STARTING - PNEUMATIC STARTER VALVE - INTRODUCTION OF REVISED EXTERNAL WIRING -  
CATEGORY CODE 7 - MOD.ENG-80-0011

**V2500-ENG-80-0011**

## STARTING - STARTER CONTROL VALVE - INCORPORATION OF A NEW SOLENOID

**Starter Control Valve - External View - Before Modification  
Figure 1**

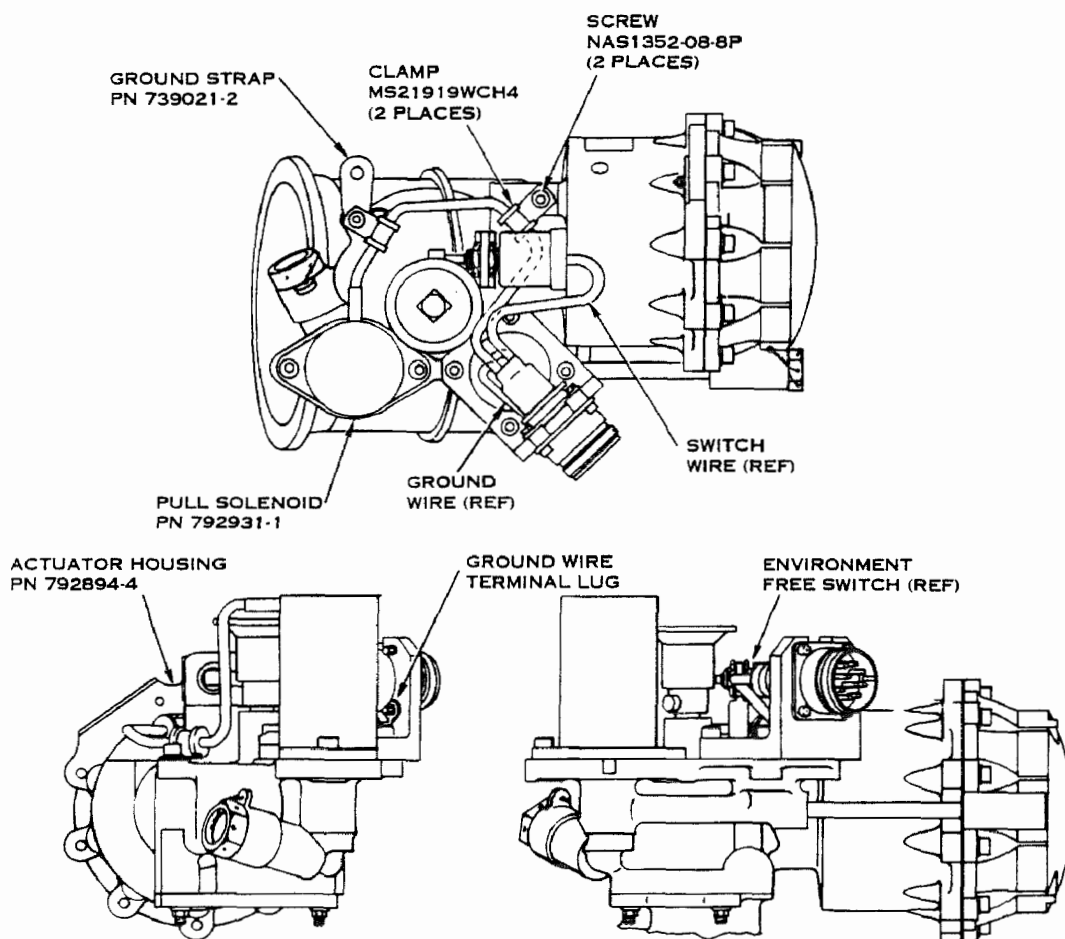
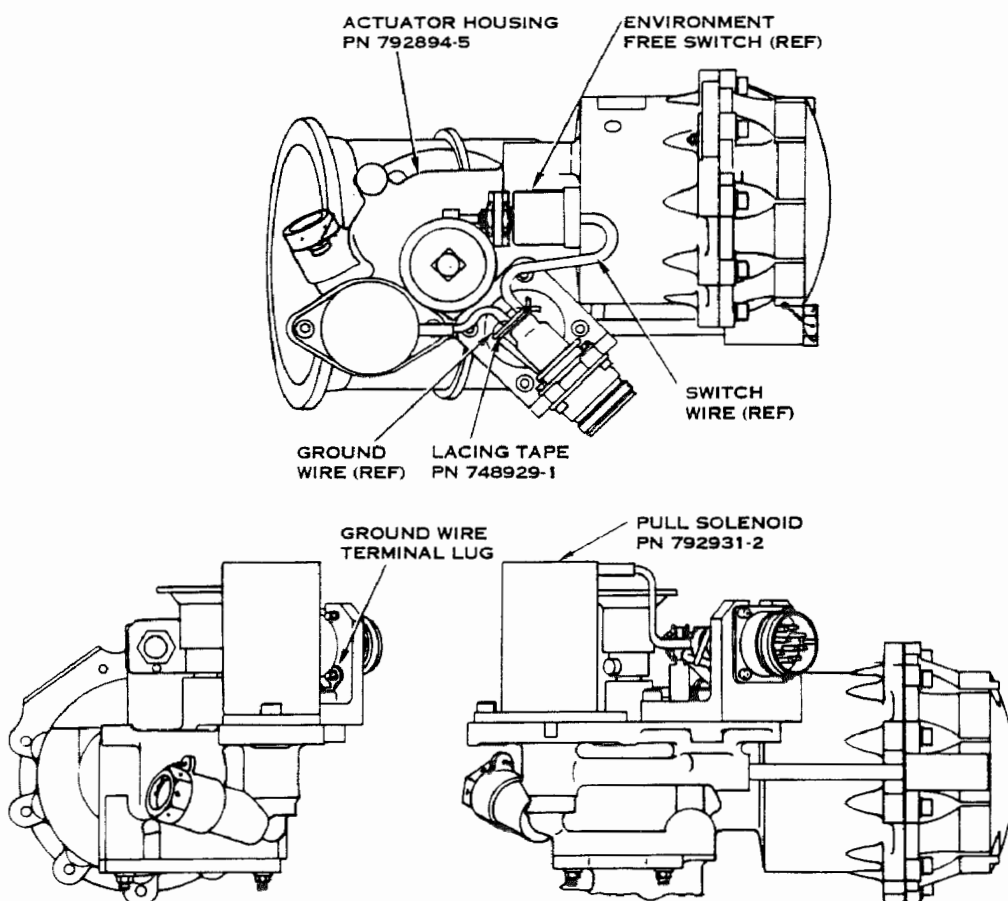
**A. Modify starter control valve, Figure 1, as follows:**

- (1) Replace pull solenoid PN 792931-1 with pull solenoid PN 792931-2.

- (2) Replace actuator housing PN 792894-4 with actuator housing PN 792894-5.

NOTE: Actuator housing PN 792894-4 does not have to be replaced for this modification, however actuator housing PN 792894-5 cannot be used on earlier configurations.

- (3) Remove and discard two clamps PN MS21919WCH4, two screws PN NAS1352-08-8P and ground strap PN 739021-2.
- (4) Assemble starter control valve in accordance with existing component maintenance manual instructions except as follows:
- (a) Install new pull solenoid PN 792931-2 on existing actuator housing PN 792894-4 or new housing PN 792894-5 and route solenoid wire to electrical connector as shown in Figure 2.
  - (b) Install ground wire and splice to new pull solenoid PN 792931-2 in accordance with REPAIR 5-1 of component maintenance manual.
  - (c) Secure ground wire of pull solenoid and environment free switch to electrical connector with lacing tape PN 748929-1. Wrap lacing tape around ground wires and connector two times and tie a square knot as shown in Figure 2.
  - (d) Trim lacing tape from knot approximately 0.500 inch. Fraying at ends permissible.

**Starter Control Valve - External View - After Modification  
Figure 2**
